**TOWN OF HUDSON
PLANNING BOARD
PUBLIC MEETING
TOWN OF HUDSON, NH
AUGUST 27, 2014**

Dairy Queen Amended Site Plan

Staff Report

SITE: 119 Ferry Street -- Map 175/Lot 142 --SP# 11-14

DATE: JULY 18, 2014 SCALE: 1" = 20'
PROJECT NO: 14-0321-1 SHEET 9 OF 13

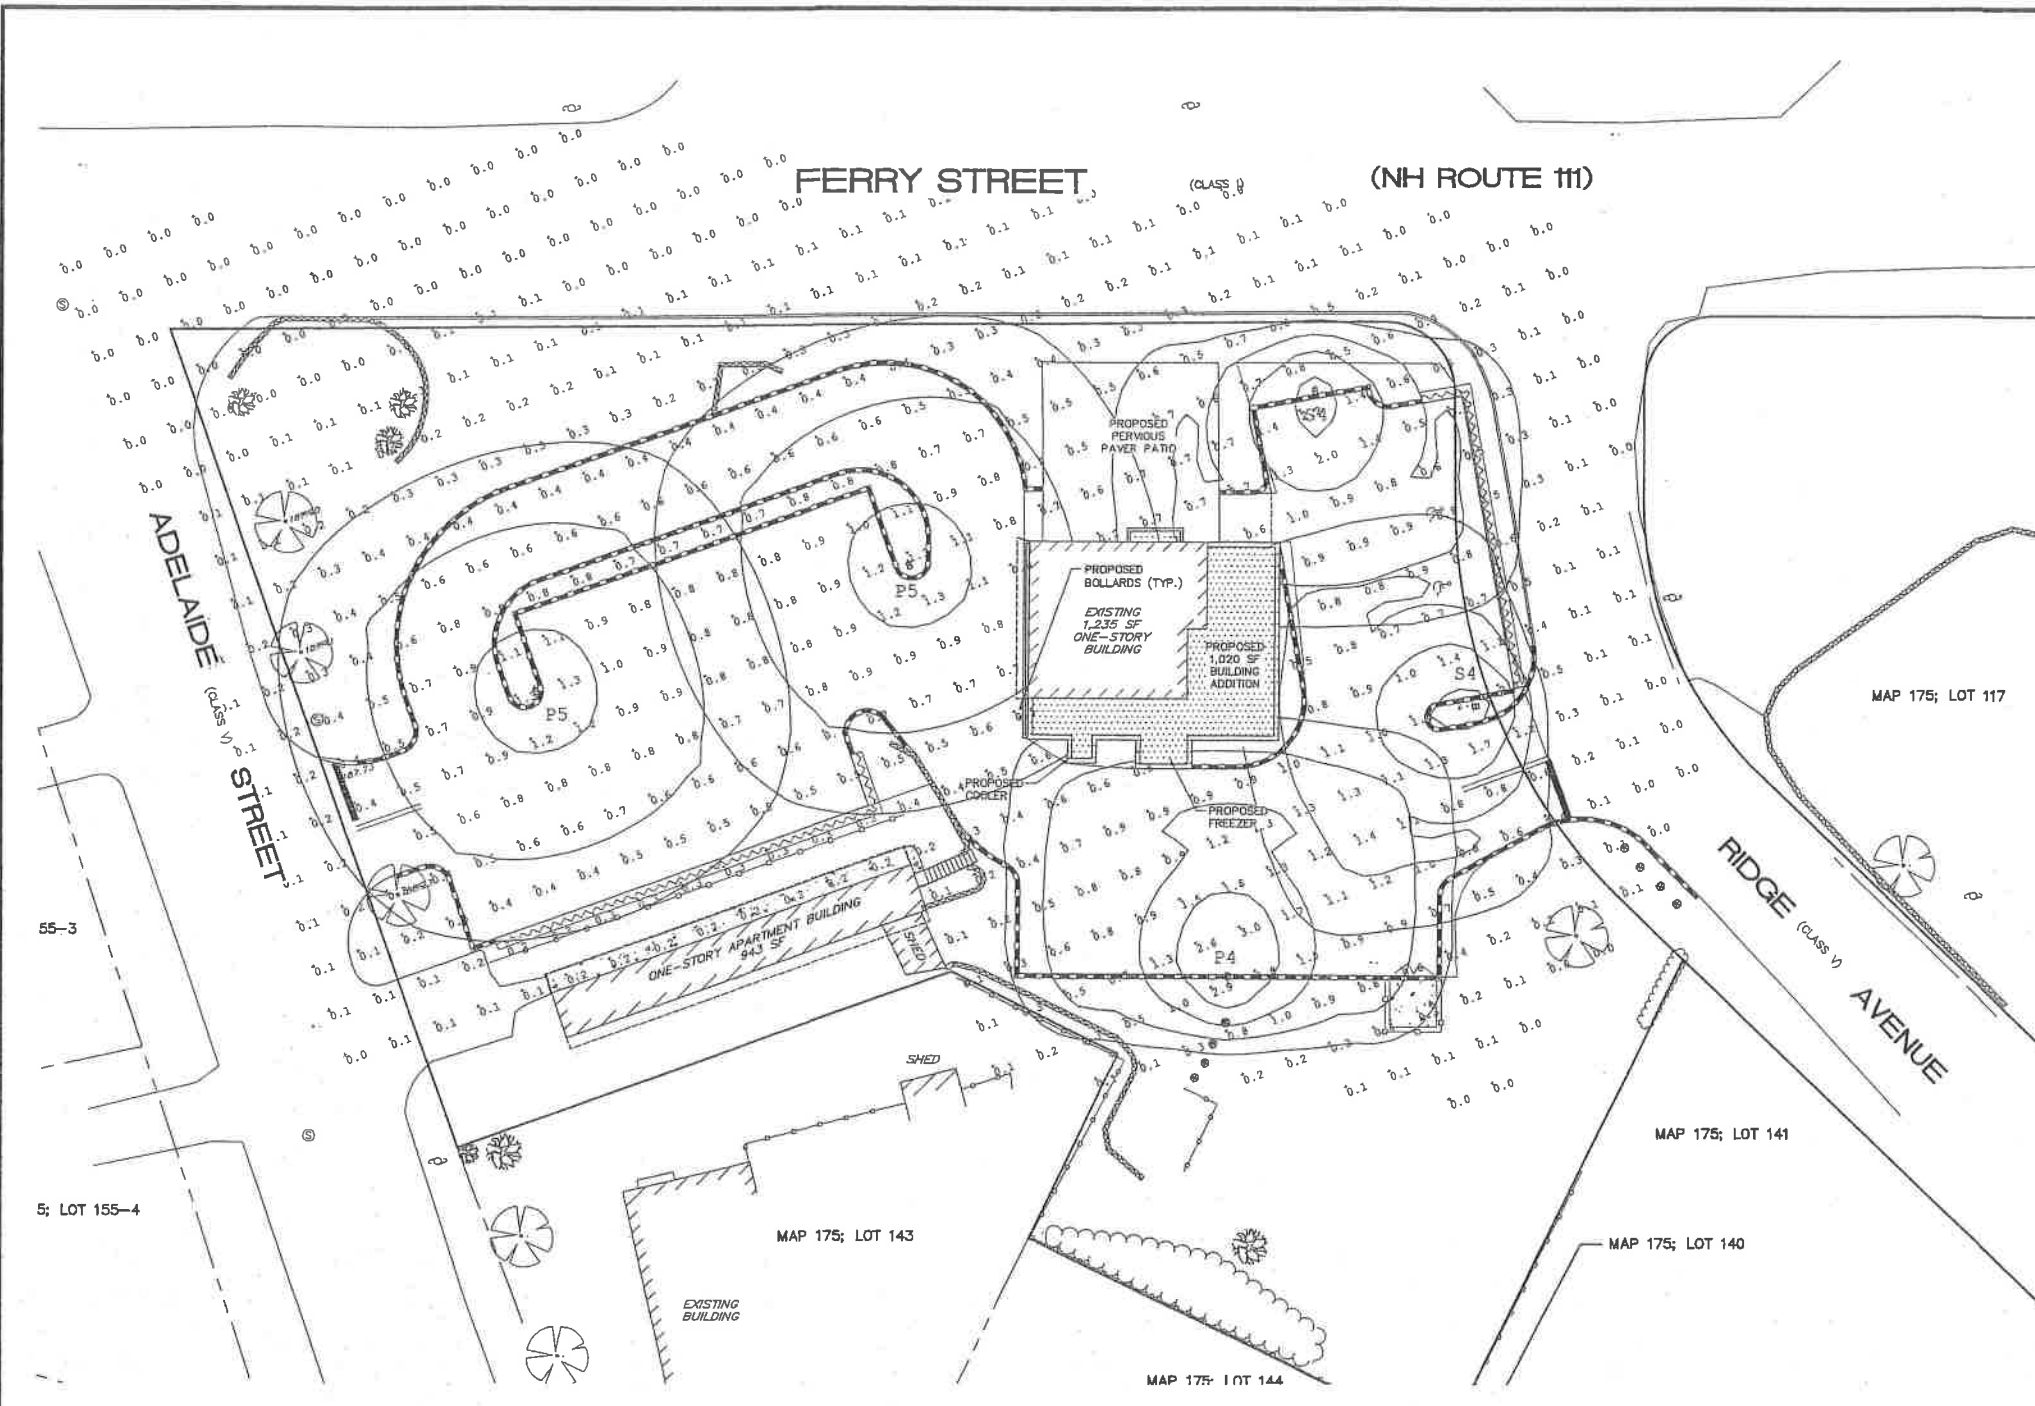
- 7) Onsite landscaping and exterior lighting shall be provided for in accordance with the Sheets 8 & 9 of the Plan.
- 8) Exterior construction activities on the site shall be limited to between 7:00 A.M. and 7:00 P.M. Monday through Saturday. No construction activities shall occur on Sunday.
